Work Order ID 74330

Item Name: Crosstube Fwd

DART AEROSPACE LTD	Work Order: 74330
Description: Crosstube High Fwd (205/212/412)	Part Number: D212-664-101
Inspection Dwg: D212-664-141 Rev: D	Page 1 of 1

DRAWING NO. D212-664-141	TITLE XTUBE ASSY (205/212/412 HI FWD)	REV. D	DART AEROSPACE LTD ENGINEERING ORDER		D.E.O. NO. D212-664-141-D-1	SHEET NO. SHEET 1 OF 2	SCALE NTS
DRAWN	CHECKED	MP	MFG. APPR.	ER	APPROVED	MP	DE APPR.
DATE	11.04.07	DATE	11.04.11	DATE	11.04.12	DATE	11.04.12

**D212-664-141/-141B
ASSEMBLY DETAIL**

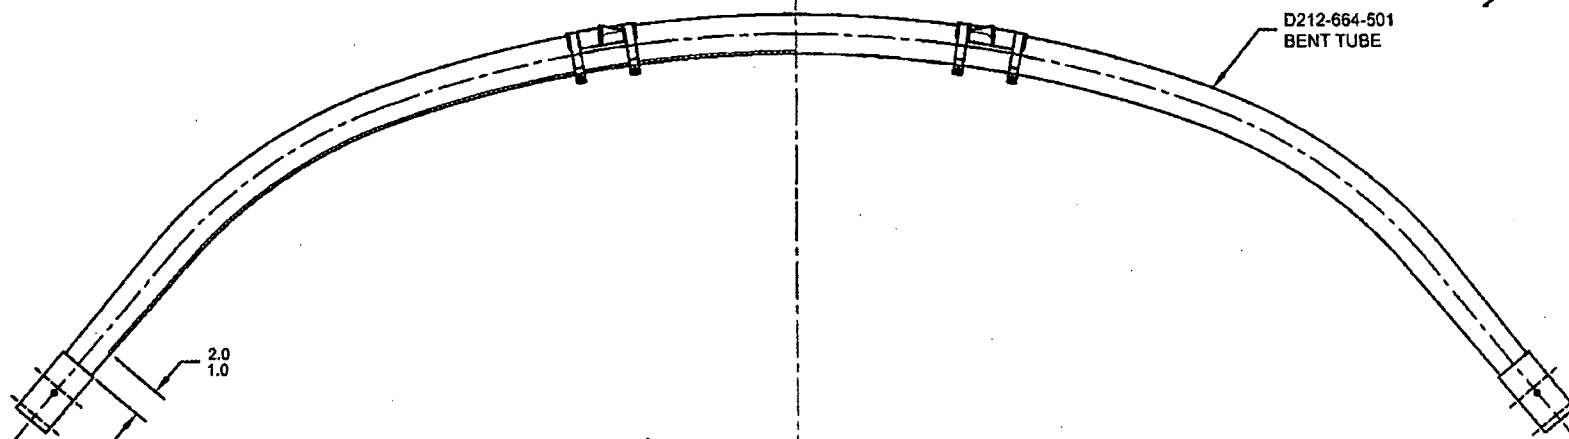
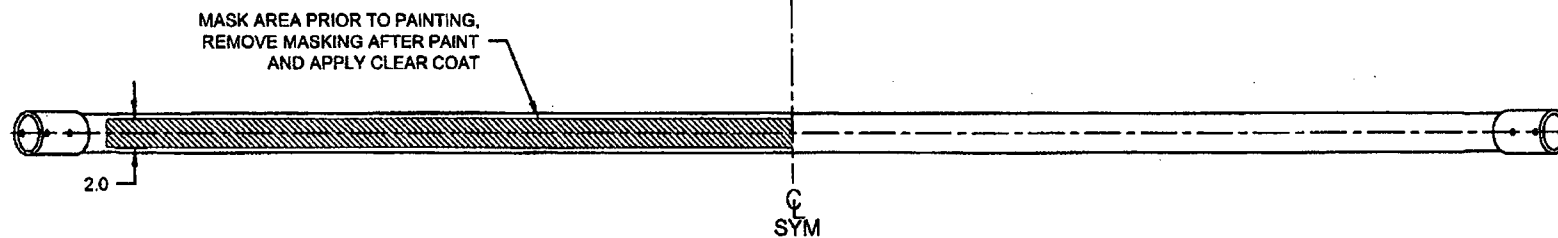
PURPOSE:

ADD AN INSPECTION WINDOW TO UNDERSIDE OF CROSSTUBE.

NOTES 2 OF SHEET 1 IS AMENDED AS FOLLOWS:

- 2) FINISH: CHEMICAL CONVERSION COAT PER DART QSI 005 4.1
PRIME INSIDE AND OUTSIDE PER DART QSI 005 4.2
MASK UNDERSIDE OF CROSSTUBE AS SHOWN (HATCHED AREA) AND
PAINT OUTSIDE PER DART QSI 005 4.2
REMOVE MASKING AND APPLY CLEAR COAT

- 2) FINISH: CHEMICAL CONVERSION COAT PER DART QSI 005 4.1
PRIME INSIDE AND OUTSIDE PER DART QSI 005 4.2
PAINT OUTSIDE PER DART QSI 005 4.2
